## Meeting Agenda Plat Committee

Monday, September 27, 2021

1. [KPB-3558](#) Alaskan Wildwood Phase  
KPB File 2021-126

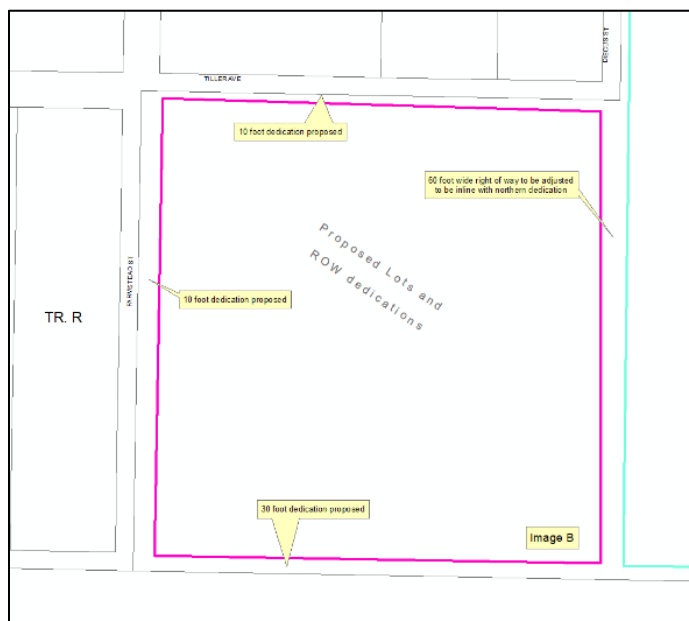
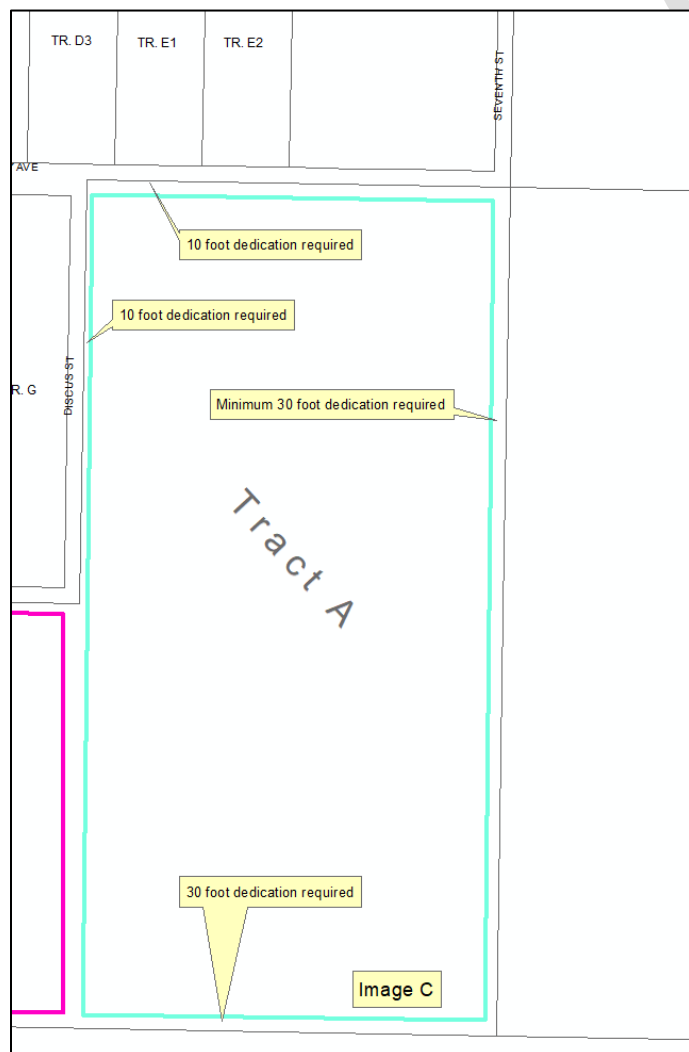
Tiller Avenue and Farmstead Street are currently 50 foot wide dedications. Sheet 2 indicates that 10 foot dedications are proposed and a 30 foot dedication along the south that coincides with a 50 foot section line easement (Image B).

A 60 foot wide dedication is proposed to provide a continuation of Discus Street. The design proposed shows a 10 foot offset from the northern dedication. This appears to be occurring due to unit locations. As discussed previously, this plat cannot change any unit design. **Staff recommends** the right of way dedication for Discus Street be 60 feet wide and align with the current dedication of Discus Street. (Image B).
